**Informal Group on gtr No 9 – Phase 2 (IG GTR9-PH2)  
6<sup>th</sup> meeting, Washington DC, 19 – 20 March 2013**

# **Discussion on Impactor Thresholds**

Presented by the pedestrian safety experts of the  
International Automobile Manufacturers' Organization (OICA)

# Comparison of Master Leg SN-03 with an OEM Leg of the Same Build Level (1)

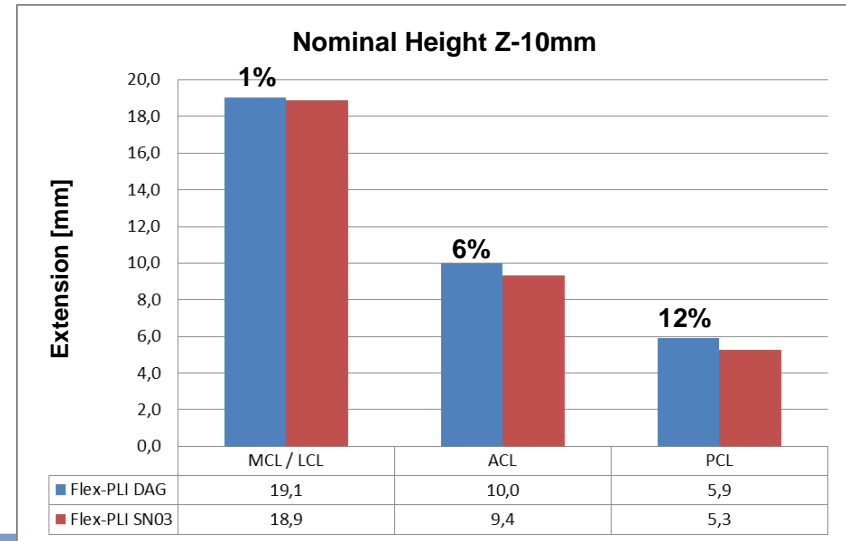
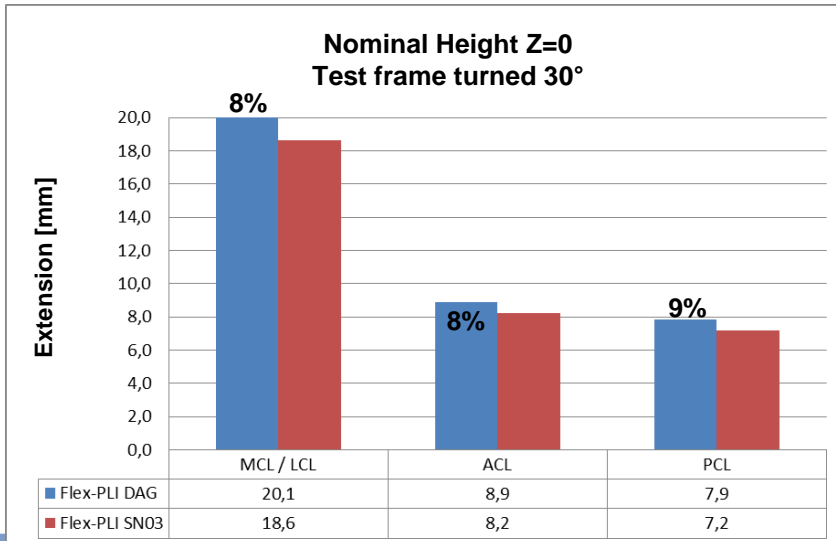
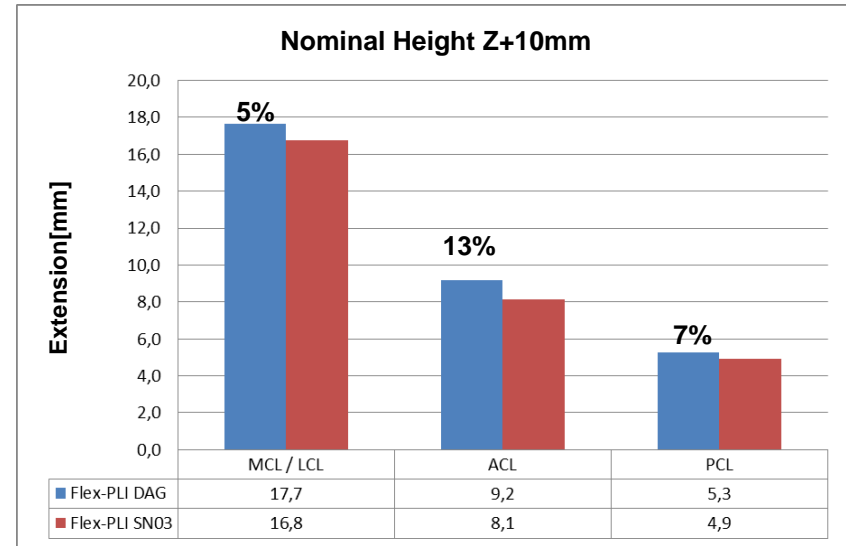
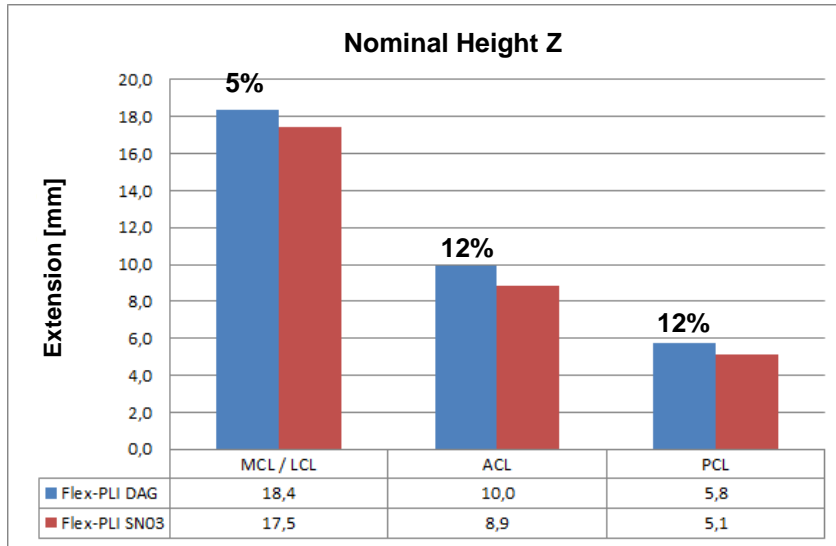
- For the study of BASt, just two legforms were used
  - ⇒ It is questionable whether the performance of two impactors can be generalized even if they are “master legs”; industry already noted that the outputs of the impactors vary considerably
  - ⇒ Tests with another impactor – that was confirmed to have the same build level as the “master legs” – show higher output values (see pages 6 and 7: tests were conducted against a test rig to guarantee that no vehicle influence can be seen, 2 tests per measuring point were conducted)

- As explained by BAST, the certification corridors for the assembled legform were shifted down, depending on the test results with the so-called “master legs”, in the inverse certification test between 2.3 % and 7.8 % for the tibia moments and between 4.8 % and 7.3 % for the ligaments; for the new injury thresholds, BAST uses only the maxima of these shiftings
- ⇒ It is incoherent to only take the maxima into consideration, especially when noting that BAST also reported in an earlier document (document GTR9-4-14 of the 4<sup>th</sup> meeting of this IG) that the legforms in repeatability tests have coefficients of variation that are even higher in some cases
- ⇒ For the definition of the new certification corridors for the assembled impactor the methodology agreed in the TEG was used; consequently, for the impactor thresholds the TEG agreed methodology should also be used

- Following the logic of BAST's approach, it now would be appropriate for Industry to require increasing the injury thresholds
  - However, Industry experts are in agreement that the results achieved in the TEG represent an acceptable compromise definition of the injury thresholds in gtr No 9
  - As already pointed out in document GTR9-5-23, all Industry activities especially regarding the assessment of the feasibility of vehicle countermeasures were based on agreements achieved in the TEG in 2009; new impactor thresholds may need further validation that would need to be considered for the schedule of the Informal Group
- ⇒ Industry therefore proposes to stick to the impactor thresholds as agreed in the TEG:
- Tibia bending moments of 340 Nm
  - MCL elongation of 22 mm
  - ACL / PCL elongation of 13 mm
